Product/Process Change Notification

Title of change	LED surface mount devices' package alteration (in keeping line with JEDEC standards).		
Affected product(s)	Product name	Customer part number	
	All surface mount devices	See Attachment Sheet	
Detailed description of change	Now	After	
	No JEDEC compliant labels or signs	①Aluminum bags with caution cards. ②Product labels → Additional information is provided in accordance with JEDEC package standards. ③HIC encapsulation	
Reason for change	To meet international standards on package specifications		
Anticipated impact on quality	(form, fit, function, reliability) Only package indication is altered. There is absolutely no change at all in terms. The quality of devices won't be affected. It is assumed that amendments to the specification sheet isn't necessary, because the changes listed above can be handled by the specification sheet.		
Identification of change	Based on Lot No.,or JEDEC display which is also available.

Product/Process Change Notification **PCN#: 5019002**

Changes that are made to Meet JEDEC Package Standards

Change 1 - Aluminum Bags

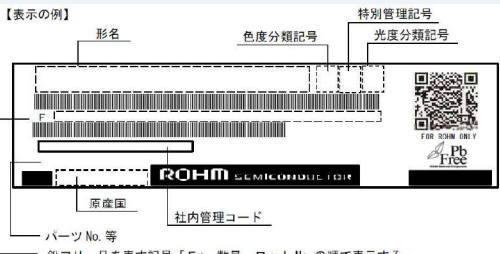
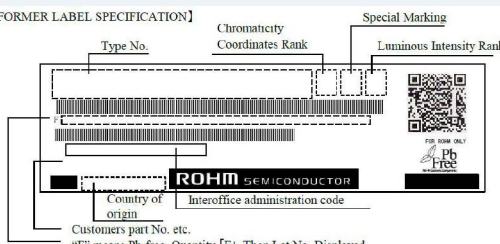
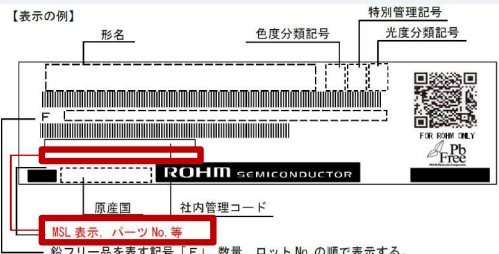
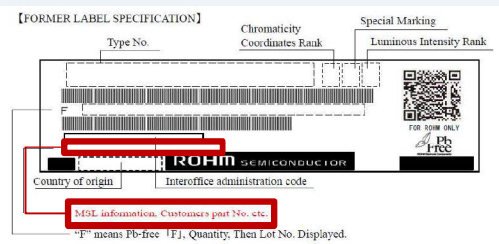
Items	変更前 Before the Change	変更後 After the Change
表面 Front Side	 <p>Aluminum zip bag</p>	 <p>チャック無し No zipper</p>
裏面 Back Side		 <p>取り扱い 注意記載印刷 Printings or symbols that suggest “handle with care” are available</p> <p>※添付写真はシールですが、実際はアルミ包装に直に印刷します ※The notice is stuck in this picture but in actual, It will be printed on the bag</p>
